UNITED STATES PATENT AND TRADEMARK OFFICE

APPLICATION NO.	FILING DATE	FIRST NAMED INVENTOR	ATTORNEY DOCKET NO.	CONFIRMATION NO.
09/816,770	03/26/2001	Tsuyoshi Kitahara	Q63724	4825

Office Action Summary

FIG. 8
Print data
D1-D4
it selects
a proper
drive signal

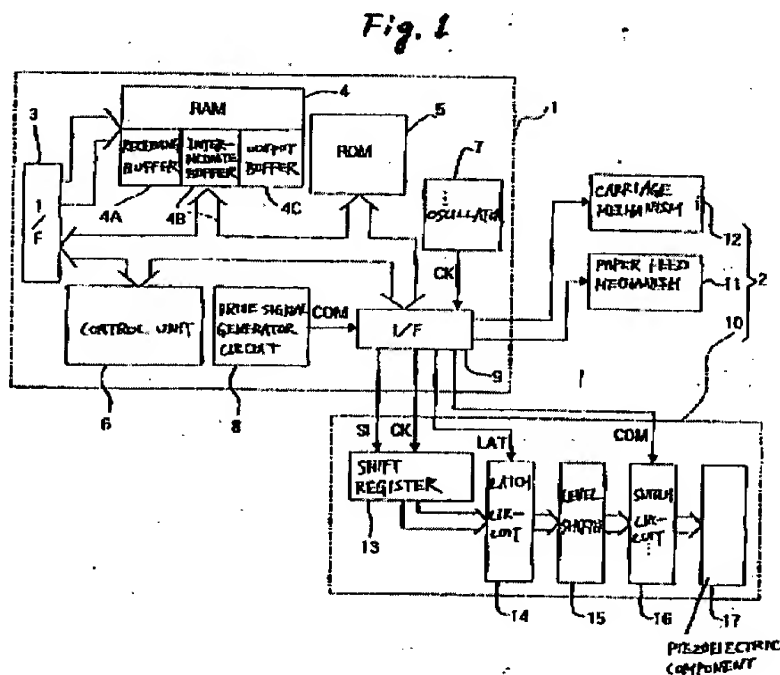
a drive signal supplier (FIG. 1, element 16) for selecting and applying M signals (one or at least two) from the N drive signals to the piezoelectric vibrators within the single jetting cycle (FIG. 9, column 14, line 43-52), where the period of the single jetting cycle (in term of "print period") is long enough to substantially damp residual vibration of a meniscus of the liquid in the nozzle orifice due to jetting by the last drive signal (column 15, line 18-20, and line 28-30)

the selected drive signals are applied at different intervals within the single jetting cycle (FIG. 9)

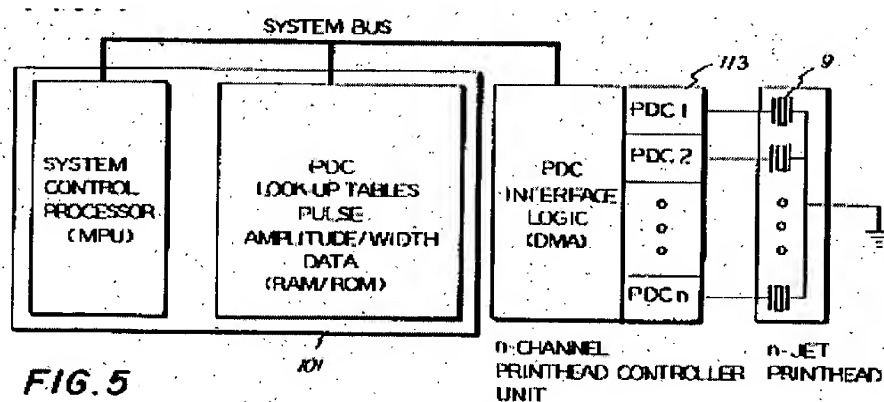
However, Bain discloses a system including a plurality of drive signal generators (in term of "programmable driver/control (PDC)") (FIG. 4 and FIG. 5, element 113) provide the different drive signals.

Therefore, it would have been obvious for one having ordinary skill in the art at the time the invention was made to substitute a plurality of drive signal generator for providing different drive signals into the design of Kitahara et al. in view of Barbehenn et al. The motivation would be that the parameters such as velocity and volume of a droplet are controlled by programming software at each drive signal generator for each different nozzle orifice as taught by Bain to obtain optimal operation of the printhead (column 1, line 46-61).
